Task A.4. Final Initial Recommendations

Technical Memorandum

St. Johns River Water Management District

May 1, 2017

Figure 2-29. Assigned Recharge Rates, 2009

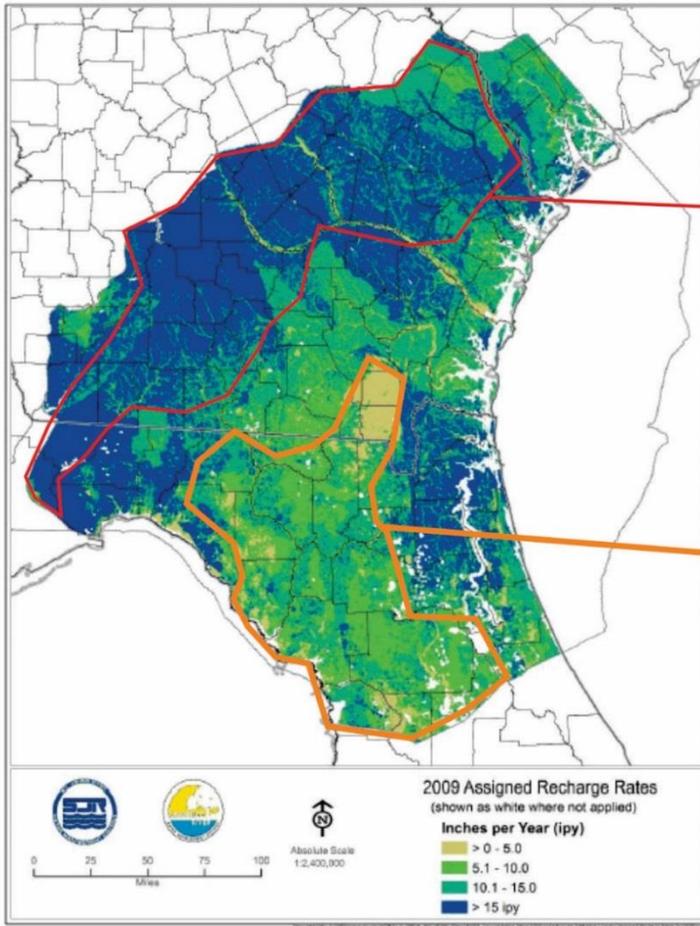
4. A map should be added showing the MOFFLOW recharge rates to the UFA (the rate crossing the top of the cells that represent the UFA).
5. The recharge rates shown in figure 2-29 seem counter intuitive. The recharge rates are highest in the northwest portion of the model domain where there is a dense stream network. In contrast, in the part of the model domain centered around the Suwannee River, there are very few streams due to the high infiltration rates, but the assigned recharge rates are some of the lowest. This needs further discussion in the report.

18. A map also needs to be added showing the MODFLOW recharge rates to the UFA (the rate crossing the top of the cells that represent the UFA).
19. The recharge rates shown in figure 2-29 seem counter intuitive. The recharge rates are highest in the northwest portion of the model domain where there is a dense stream network (figure shown below); it seems probable that this area should have high runoff rates and low recharge rates. In contrast, in the part of the model domain centered around the Suwannee River, there are very few streams due to the high infiltration rates, but the assigned recharge rates are some of the lowest. This needs further discussion in the report.

Figure 2-25. NHDPlusV2 Flow-Line Sub-Segments Used in River- and Drain-Package Implementations

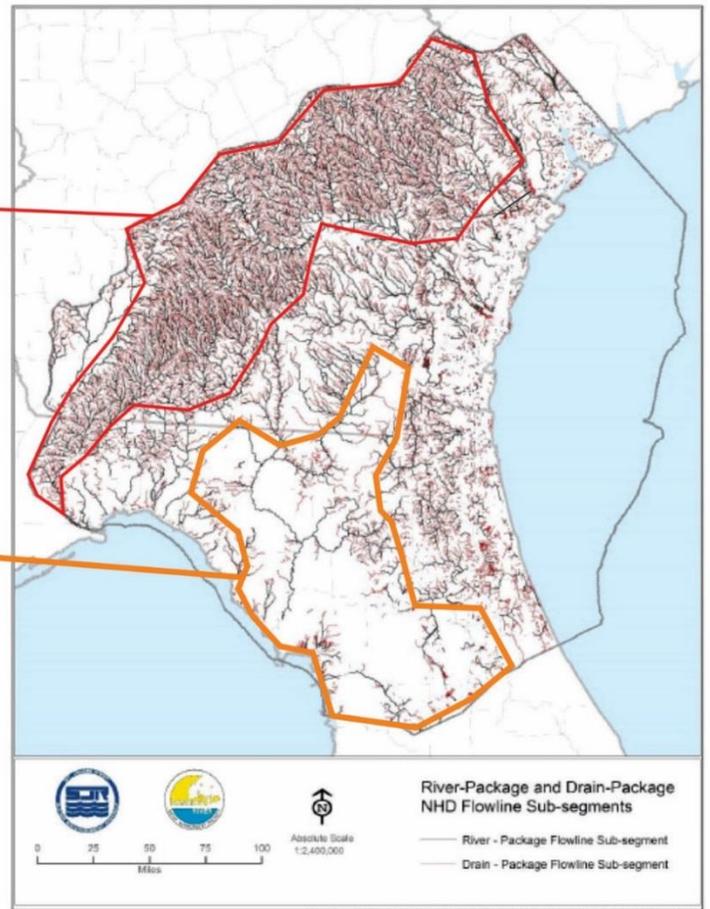
2. Figure 2-25—Not very useful at this scale.
3. Figures 2-28 through 2-31—need better contrasting colors. Delete (ipy)
4. Figure 2-36—Avoid acronyms from figure title. Spell out DSS.
